ATTACHMENT 2

PROPOSED REVISED TECHNICAL SPECIFICATION PAGES

AMENDMENT NO.      FACILITY OPERATING LICENSE NO. DPR-31

DOCKET NO. 50-250 AND 50-251

Figure 3.1-1a

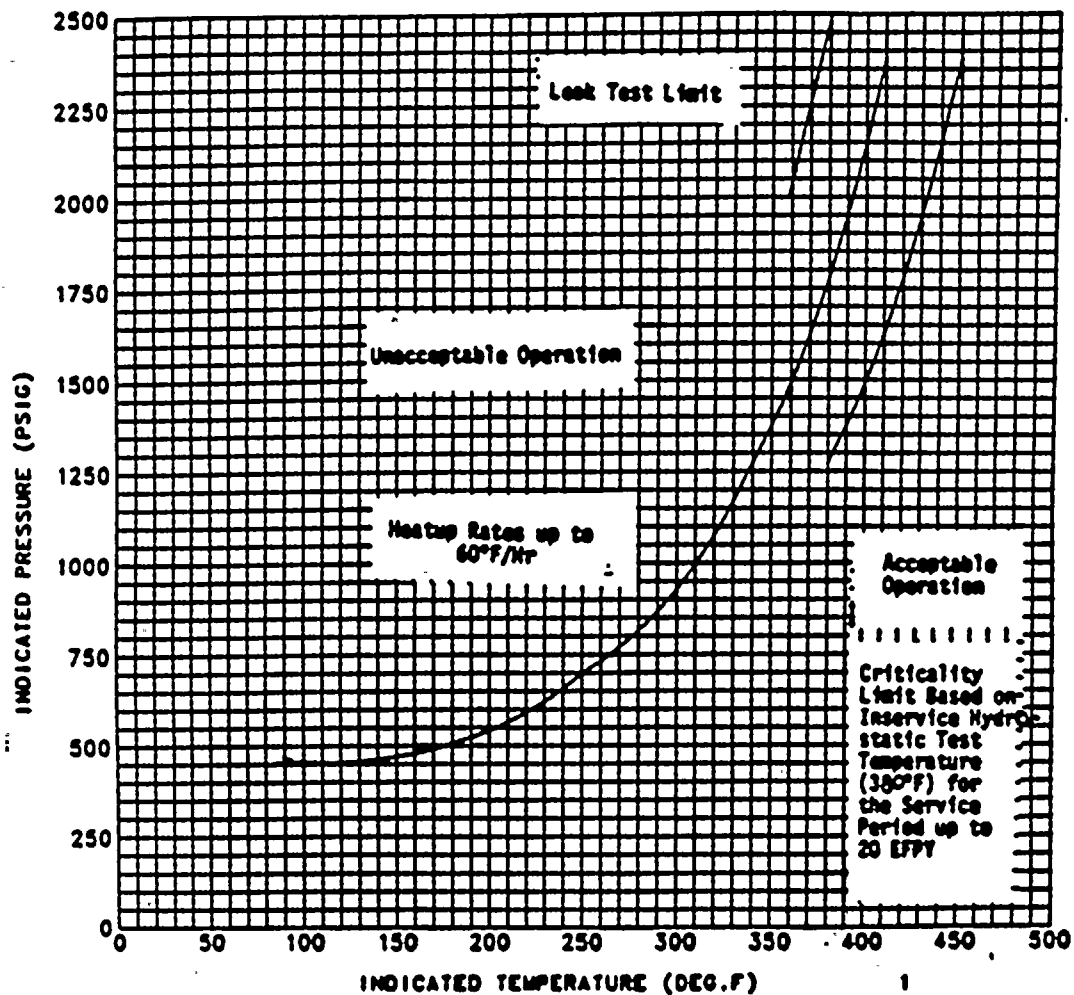
3.1.2a The Reactor Coolant System (except the pressurizer) temperature and pressure shall be limited in accordance with the limit lines shown on Figures 3.1-1a, 3.1-1b and 3.1-1c for both Unit 3 and Unit 4 during heatup, cooldown, criticality, and inservice leak and hydrostatic testing with:

CURVES APPLICABLE FOR HEATUP RATES UP TO 60°F/HR FOR THE SERVICE PERIOD UP TO 20 EFPY. NO MARGINS ARE GIVEN FOR POSSIBLE INSTRUMENT ERRORS.

Figure 3.1-1b

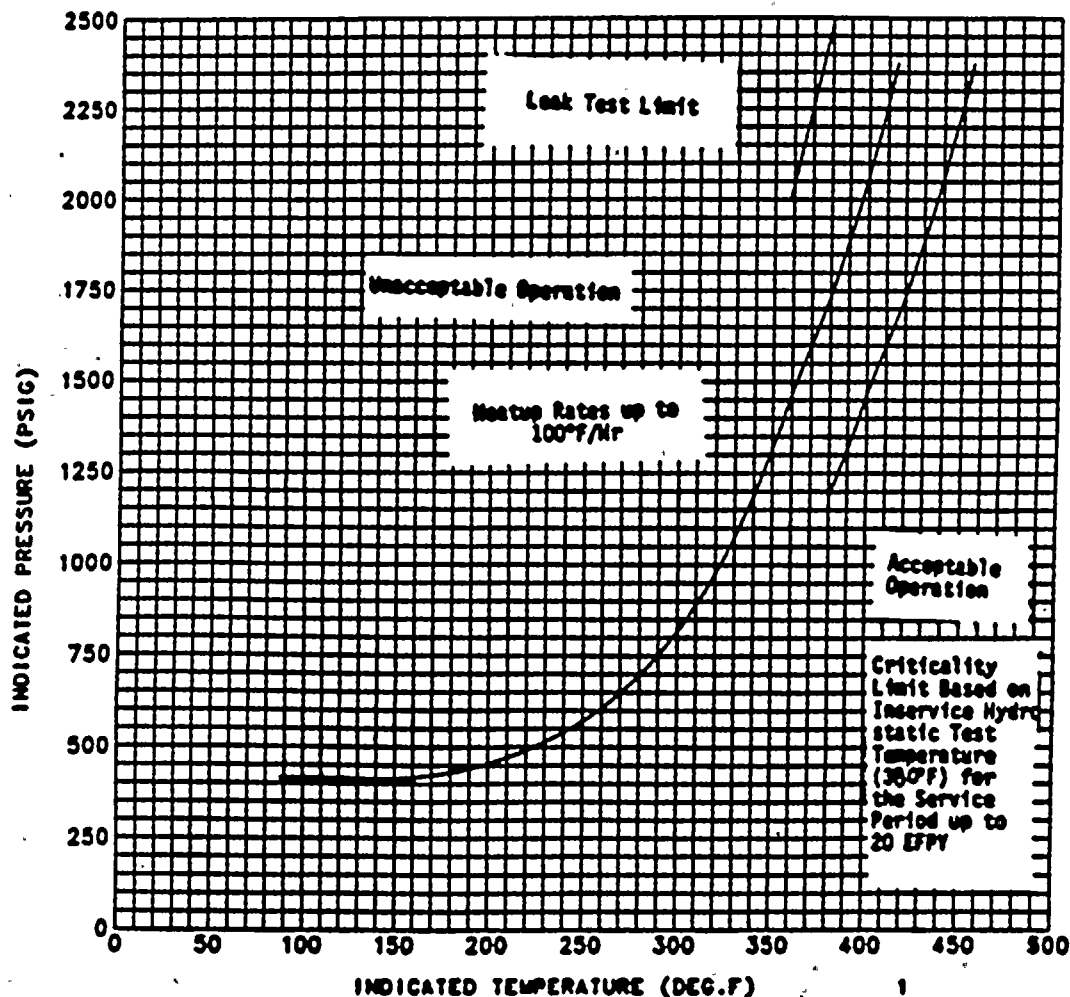
CURVES APPLICABLE FOR HEATUP RATES UP TO 100°F/HR FOR THE SERVICE PERIOD UP TO 20 EFPY. NO MARGINS ARE GIVEN FOR POSSIBLE INSTRUMENT ERRORS.

Figure 3.1-1c

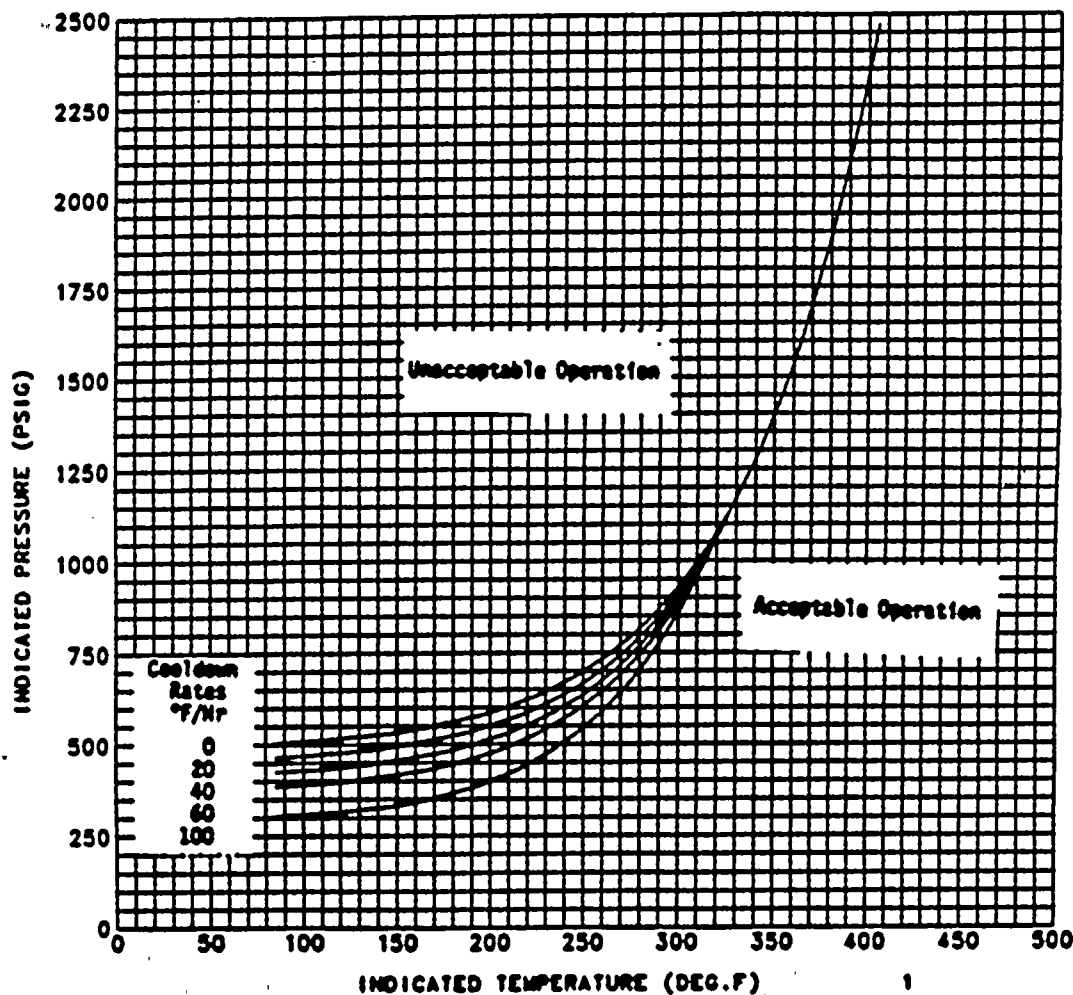
CURVES APPLICABLE FOR COOLDOWN RATES UP TO 100°F/HR FOR THE SERVICE PERIOD UP TO 20 EFPY. NO MARGINS ARE GIVEN FOR POSSIBLE INSTRUMENT ERRORS.
